INDEPENDENT HEARING AND ASSESSMENT PANEL
CONCEPT PLAN FOR CATHERINE HILL BAY & GWANDALAN

FINAL REPORT

The Independent Hearing and Assessment Panel for Catherine Hill Bay and Gwandalan has prepared this report to provide the Minister for Planning with its final views on the Catherine Hill Bay and Gwandalan Concept Plan and Project Applications submitted by the Rose Property Group Pty Ltd.

CATHERINE HILL BAY CLIFF LINE ANALYSIS

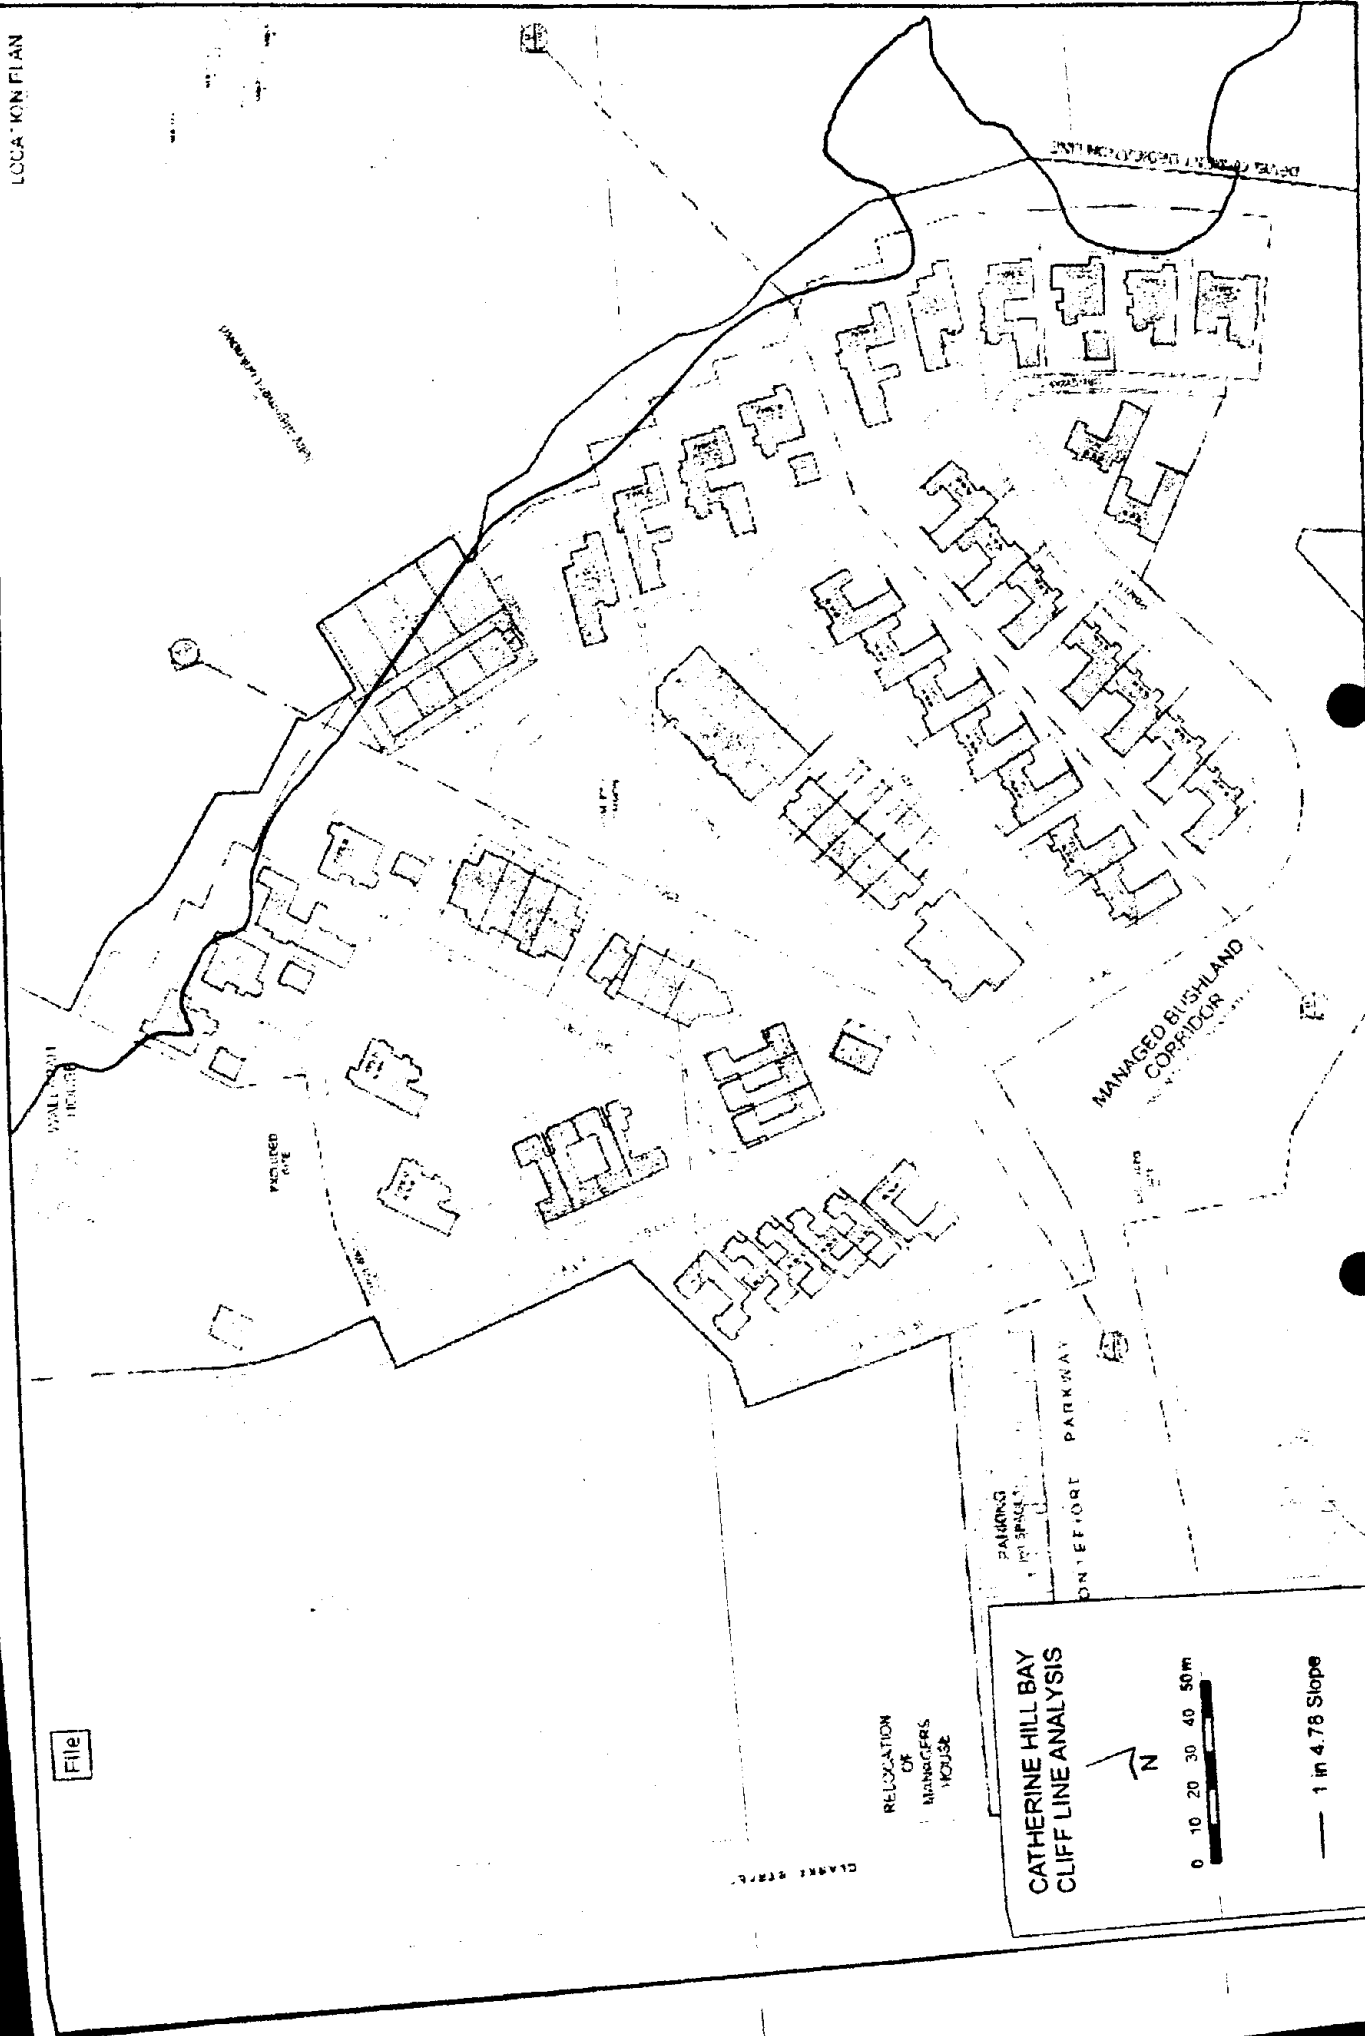
The cliff line, as defined, is as shown on Figure 1 below.

The Panel is of the view that the proposed coastal walk should be a minimum width of 25m to ensure adequate width for the walk itself and an appropriate setback from the cliff edge to mitigate against cliff retreat, ensure cliff stability etc.

It is also considered that dwellings on adjacent allotments should be setback a minimum of 15m from the allotment boundary to ensure visual separation between the coastal walk and private dwellings.

For the purpose of identifying the 25m setback requirement the Panel recommends that the "cliff edge" is defined as the line that represents the point where the land at the cliff edge has a slope of 1 in 4.78 or 20.9% (refer Figure 1 in main body of report).
